UNITED STATES PATENT AND TRADEMARK OFFICE

APPLICATION NO.	FILING DATE	FIRST NAMED INVENTOR	ATTORNEY DOCKET NO.	CONFIRMATION NO.
09/516,753	03/01/2000	Gregory Pinchasik	2390/49701	3706

Office Action Summary

BERRY (Figs. 5 as shown below, for example) discloses a stent of stainless steel or nitinol:

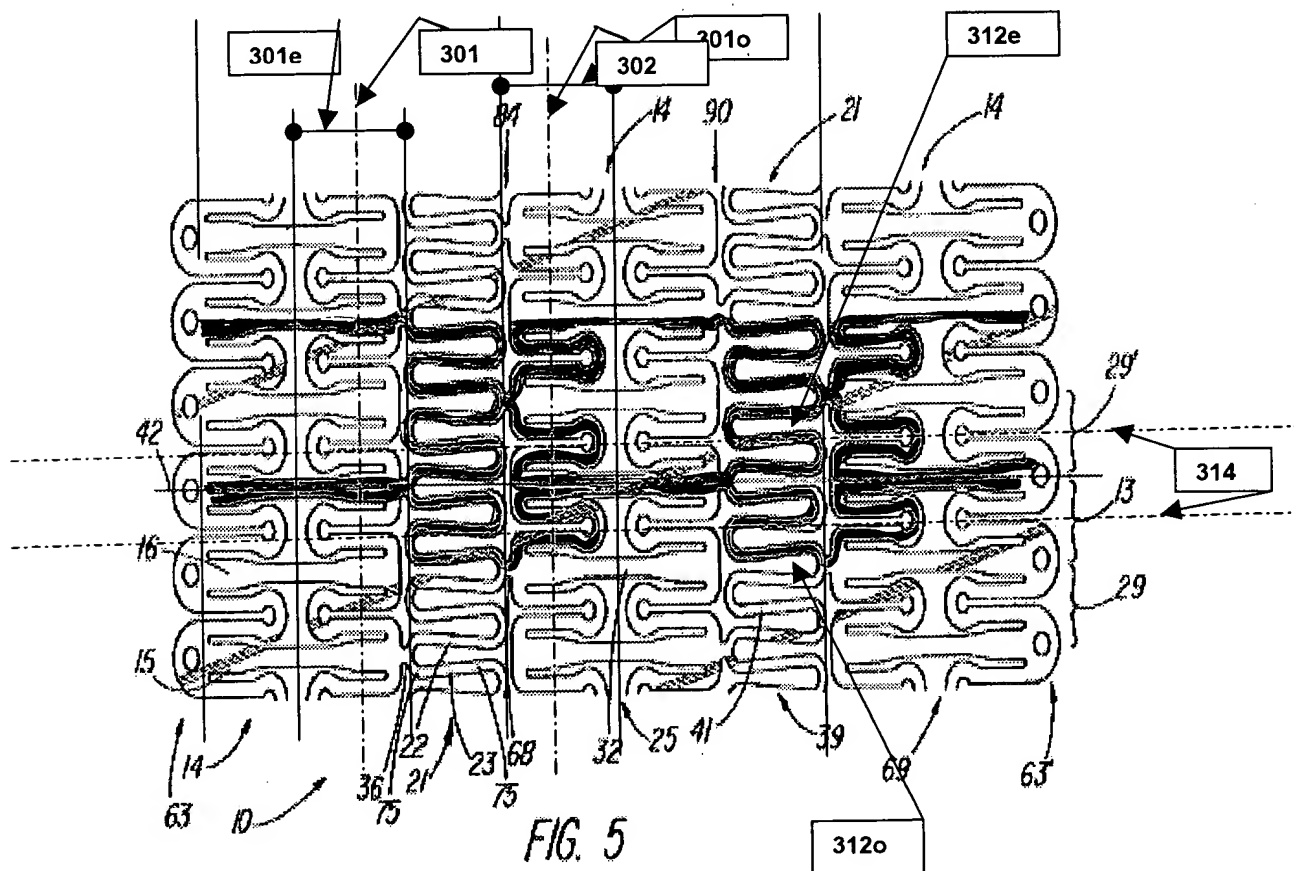
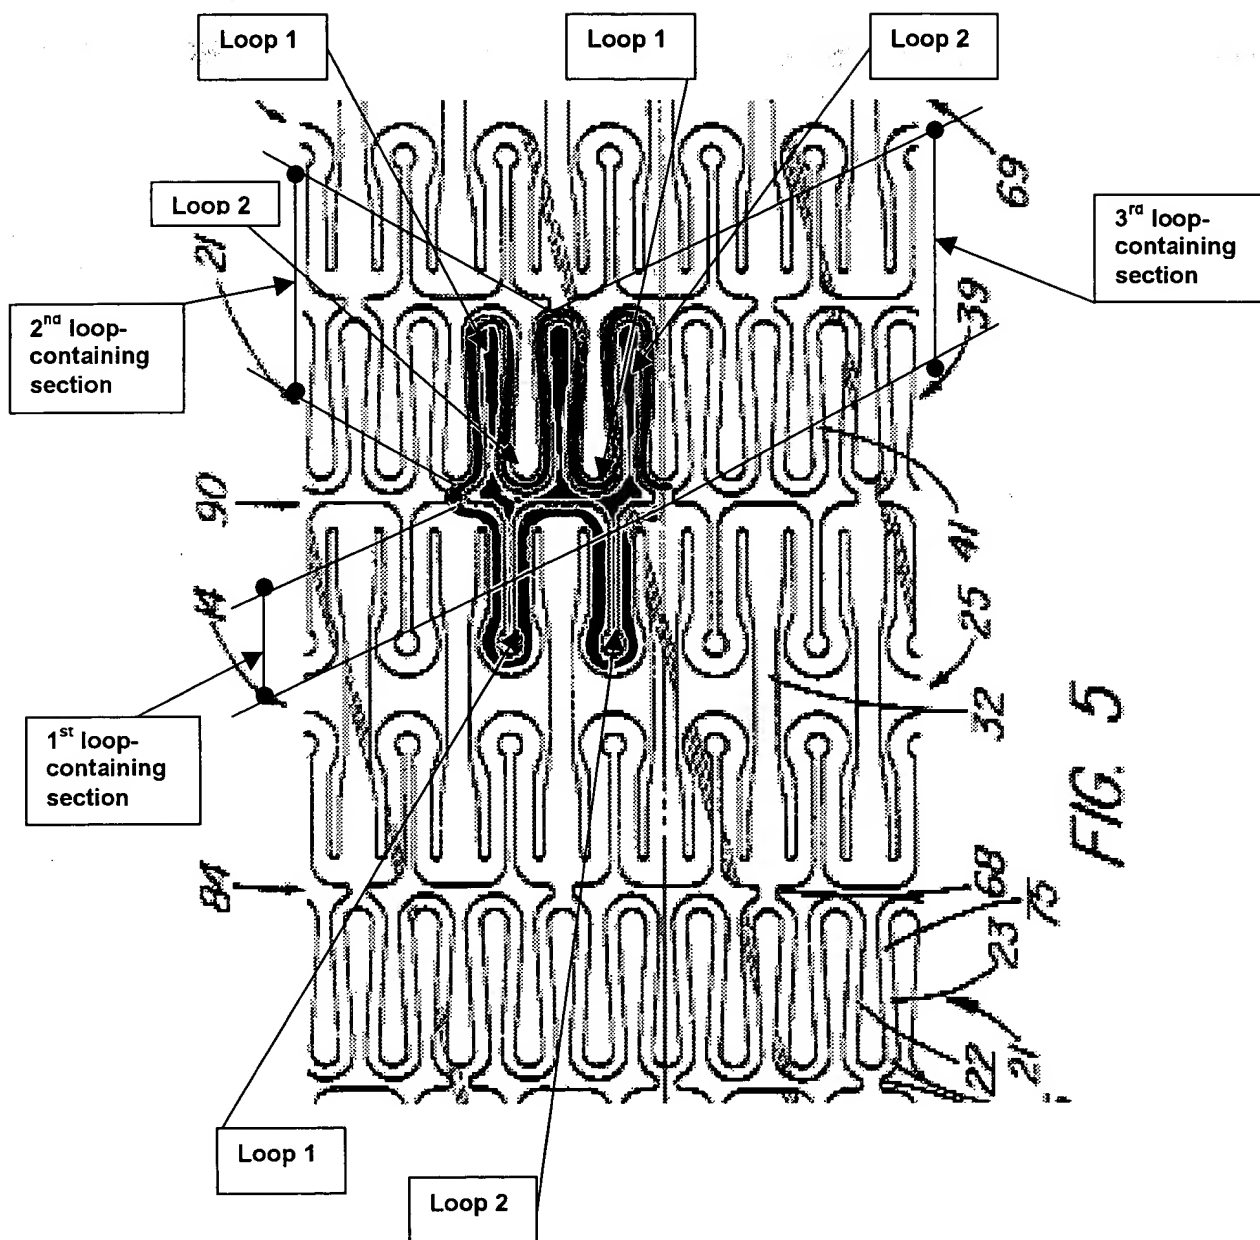
As to claims 1-7, 9-10 and 45, BERRY (Fig. 5, page 4 this paper) discloses: 1st loop-containing section (highlighted in brown), 2nd loop-containing section (green) and 3rd loop-containing section (purple). The 1st, 2nd and 3rd loop-containing sections form triangular cells (highlighted in yellow), wherein each cell covers the same area. Notice that 1st loop-containing section has wider struts than the 2nd and 3rd loop-containing section, each loop-containing section has two loops, 1st and 2nd junction points are circumferential aligned.

As to claims 21-25, 27-32, 37-46, and 48—50, BERRY (Fig. 5, page 3, this paper) discloses vertical meander/first meander pattern (highlighted in red) with centerlines 301 and horizontal meander/second meander pattern (in green) with centerlines 314. The centerlines 301 of the vertical meander/first meander pattern are orthogonal to the centerlines 314 of the second/horizontal meander patterns. The vertical/first meander patterns include even vertical/first meander patterns 310e and odd vertical/first meander patterns 310o. The second/horizontal meander patterns include even horizontal/second meander patterns 312e and odd horizontal/second meander patterns 312o. Notice that the first/vertical meander patterns have two loops per period and the second/horizontal meander patterns have 4 loops per period as shown.

FIG. 5 (for reference of claims 67-92)

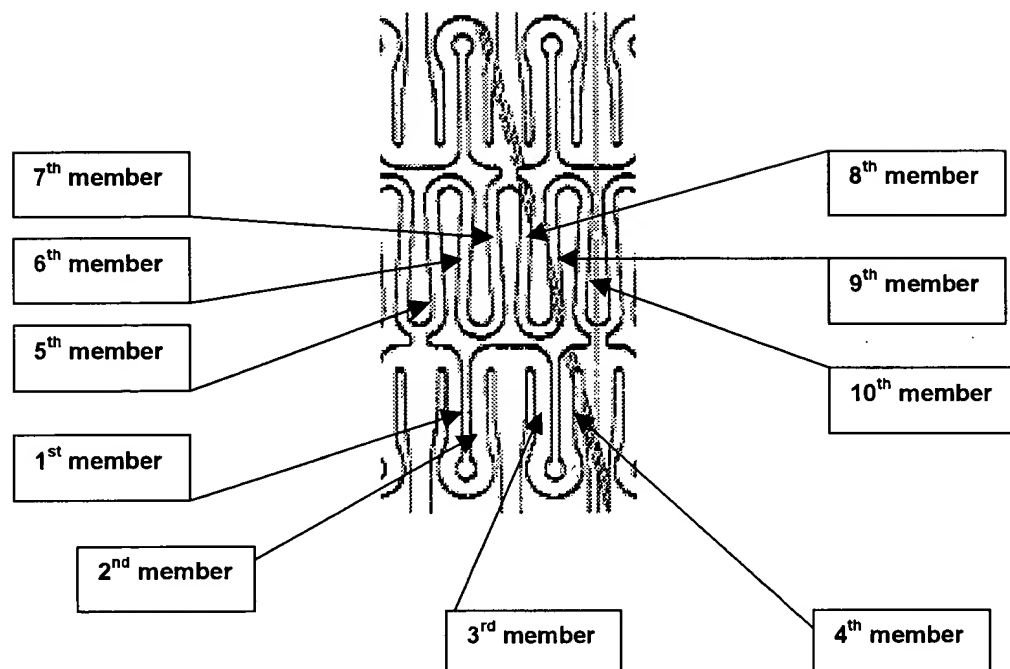
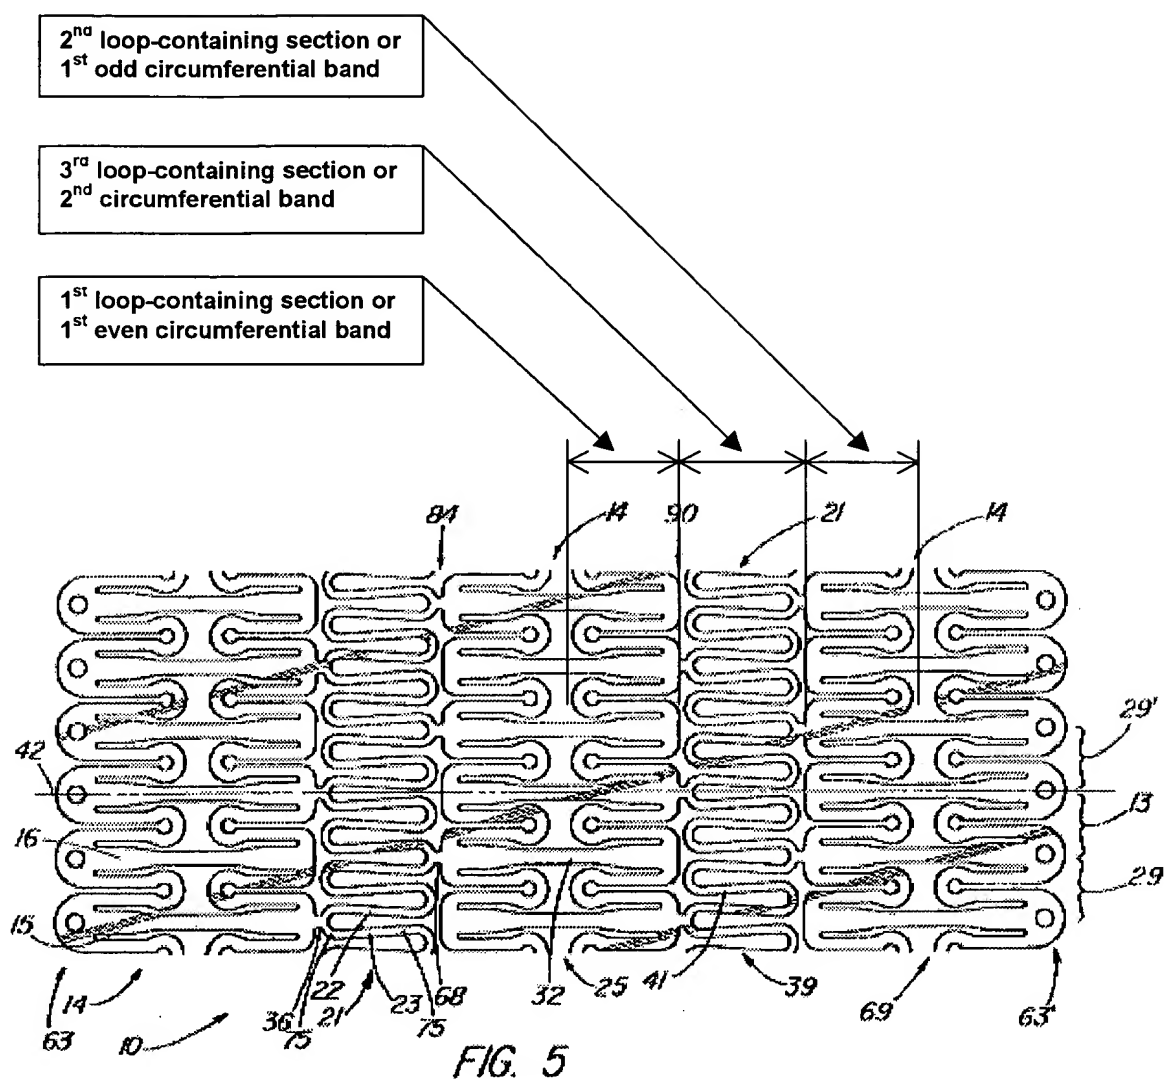
As to claims 67-70, 72-75, 77-81, 83-84, 86-88, and 90-91, BERRY (Fig. 5, this paper) discloses stent of stainless steel or nitinol having 1st, 2nd, 3rd, 4th, 5th, 6th, 7th, 8th, 9th, and 10th members which are interconnected as recited in the claims. The curved junction portions of the members define loops (shown in Fig. 5, page 6) as recited in the claims.

As to claims 95-104, 106-114, and 115-117, BEERY (Fig. 5, also Fig. 5 on page 7, this paper) discloses an even first loop containing section 301e/first circumferential band, an odd first loop containing section 301o/first circumferential band and third loop containing section/second circumferential band disposed between the first and second loop containing sections. The first or second loop containing sections (or the first circumferential band) and the third loop containing section (or the second circumferential band) defines loops as recited in the claims.
